Access Compliance Report Public Rights-of-Way (Curb Ramps)

Main Street: TRUMPET_VINE_ST		Cross Street: AMARYLLIS_ST		Location:	NE
ADA ID: RPAT211102104604	Ramp Type: Type 4 - Parallel	Initial Pass/Fail: Fail	Overall Compliance: No	Severity Score:	2
Codes/Mitigation Info/Possible Solution			Field Measurements/Component Compliance

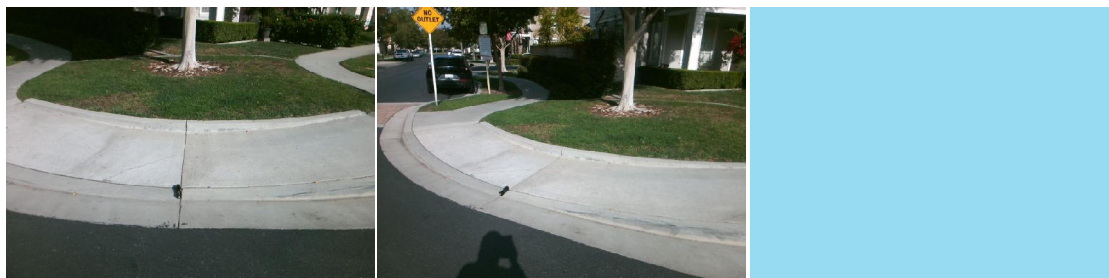
R204.3, R304.5.3, STD 1115

Remove & Replace Curb Ramp With Two New Directional Ramps or Equivalent.
